Reference: Oregon State University TRIGA Reactor (OSTR)
Docket No. 50-243, License No. R-106
Request for Additional Information (RAI) Regarding License Renewal, Oregon
State University TRIGA Reactor (TAC NO. MC5155) dated May 21, 2007

Subject: Additional Oregon State University Response to RAI Regarding License Renewal,
Oregon State University TRIGA Reactor dated May 21, 2007

Further Responses to RAI Letter of May 21, 2007

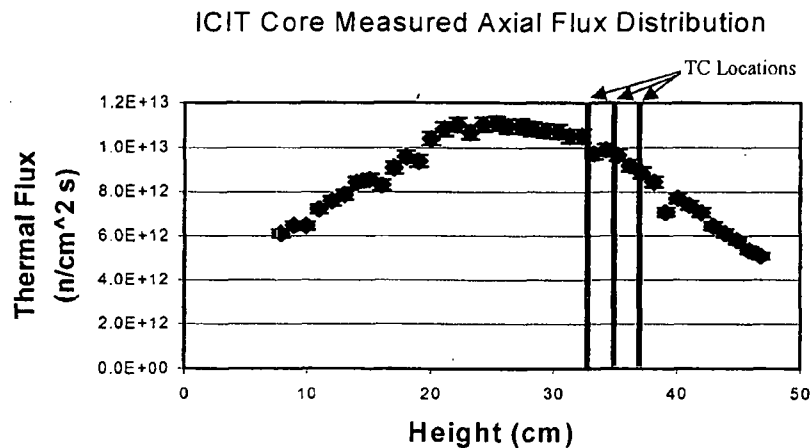
3. **What is the maximum fuel element power for possible core loadings (#8)? What are the peaking factors? Tables 4-11 and 4-12 only contain average power per element.**

The power per fuel element was calculated using MCNP5 with a model for a core similar to core #8 at a power of 1.1 MW. The new (MCNP5) model represents the reference HEU core (i.e., the original core loaded in 1976) and contains 4 less elements than core #8. The MCNP5 model for the reference HEU core was found to have very good predictive capability over a wide range of reactor conditions and was deemed to be well-suited for performing neutronics calculations. Since 1976, five elements have been removed from the core periphery and the core configuration has changed. This will have an effect of increasing the power per element by approximately 250 W, but not more than 1 kW. The results of this model can be seen in the following table:
